T-MOBILE OFFICE BUILDING

MAJOR SITE PLAN AMENDMENT

COVER SHEET

1 BUILDING NORTH ELEVATION
B 1/4" = 1'-0"

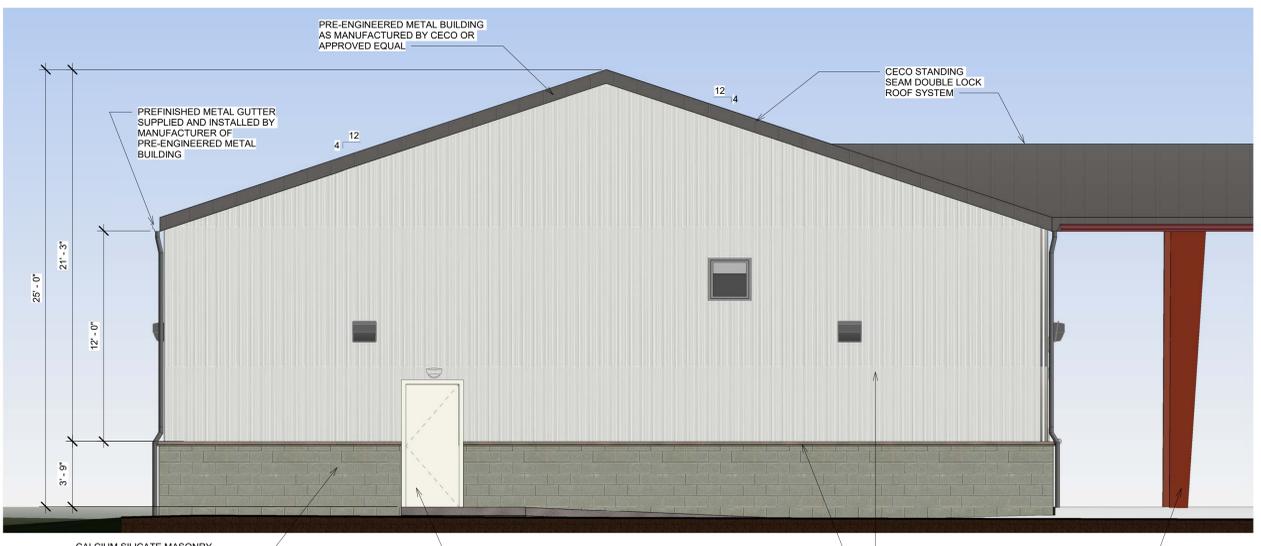
Label the finish of the steel column. Exposed metal on any elevation shall not be unfinished.

Please provide a symbol, legend & location of FDC, Knox Box, riser room and fire door to the riser room on E-1 Sheets.

Label the overhead door m. Add

1 BUILDING NORTH ELEVATION
1/8" = 1'-0"

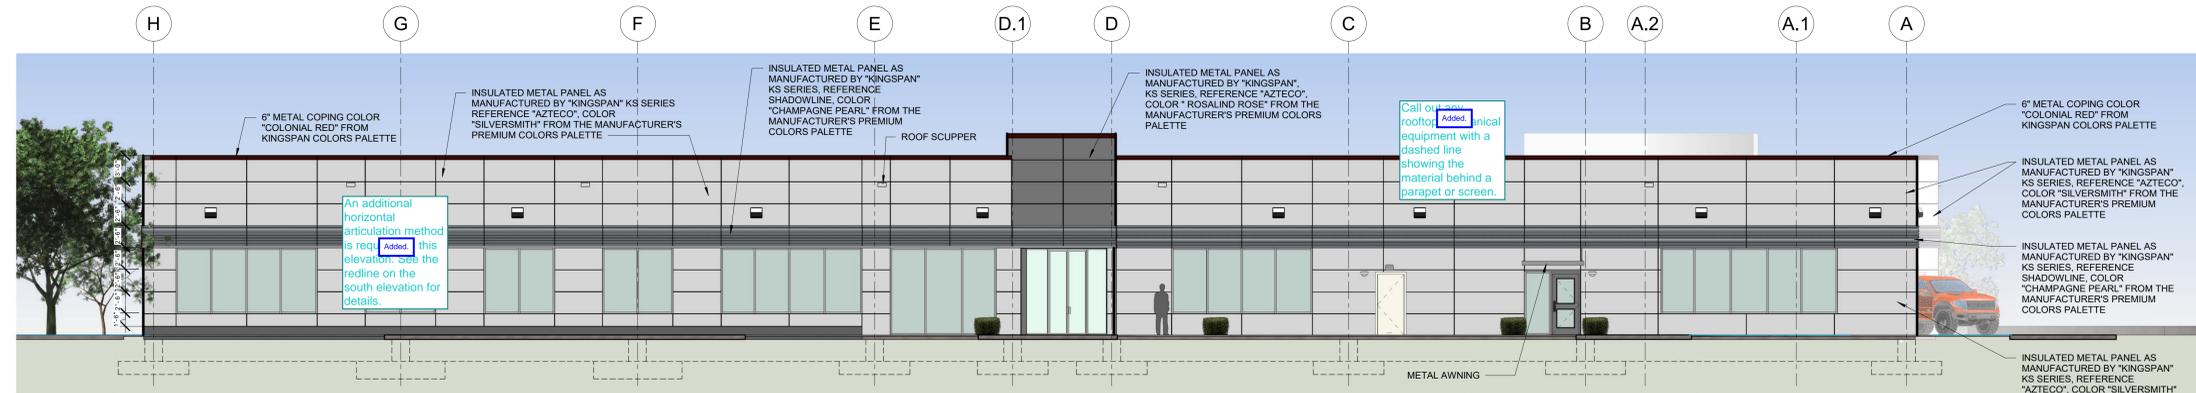
Generally, the facade character elements required for Special Purposes districts are not being met on the facade (west). Character Elements found in Table 4.8-8 need to be shown on the elevations here. Please provide additional elements to comply with this second submission.

Add a note for the roof material, Table 4.8-10 is permitted material.

2 BUILDING EAST ELEVATION
1/8" = 1'-0"

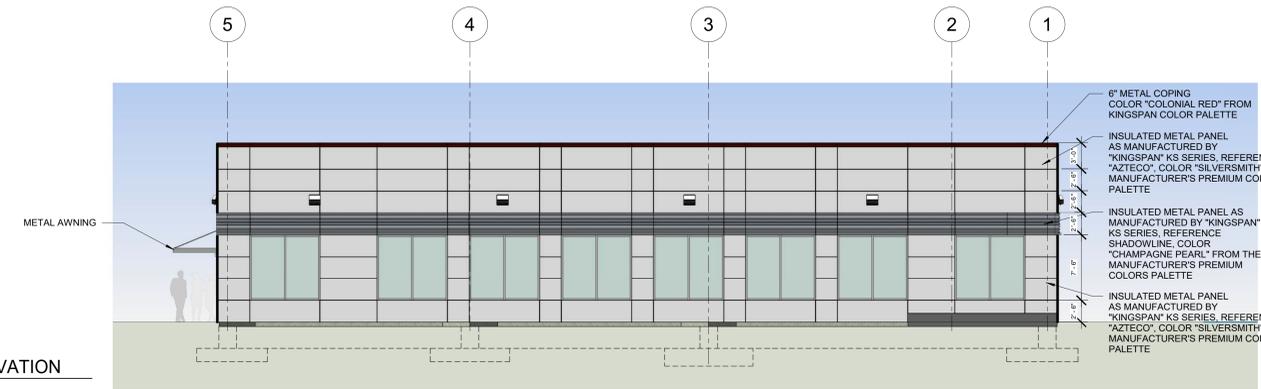
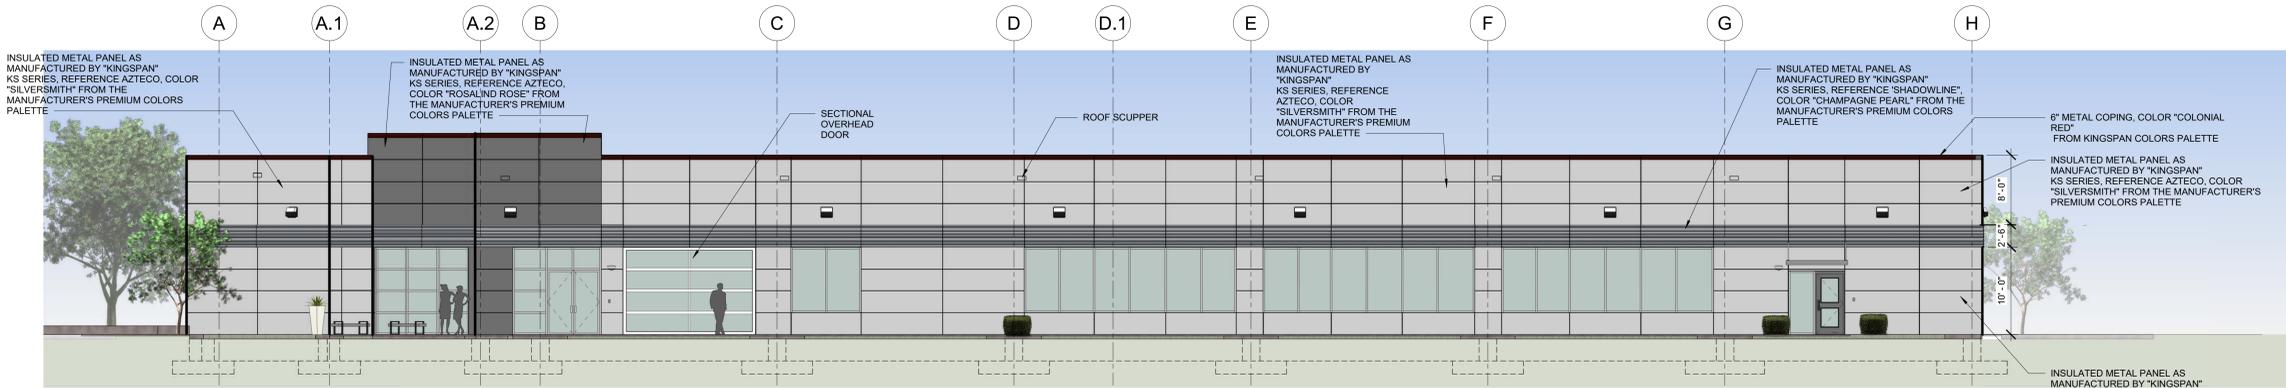
Label all glass spandrel. Glass is tinted but meets UDO requirements. Transparency labels have been added. The glass tint is for energy efficiency.

Provide horizontal dimensions on these elevation plans.

Please provide a symbol, legend & location of FDC, Box, riser room and exterior door to the riser room on Elevation Sheets.

Horizontal articulation is required once every 100 linear feet. A change in roof height counts as an articulation method. Please see table 4.8-3 for details. The eastern portion of the facade is taking an articulation method.
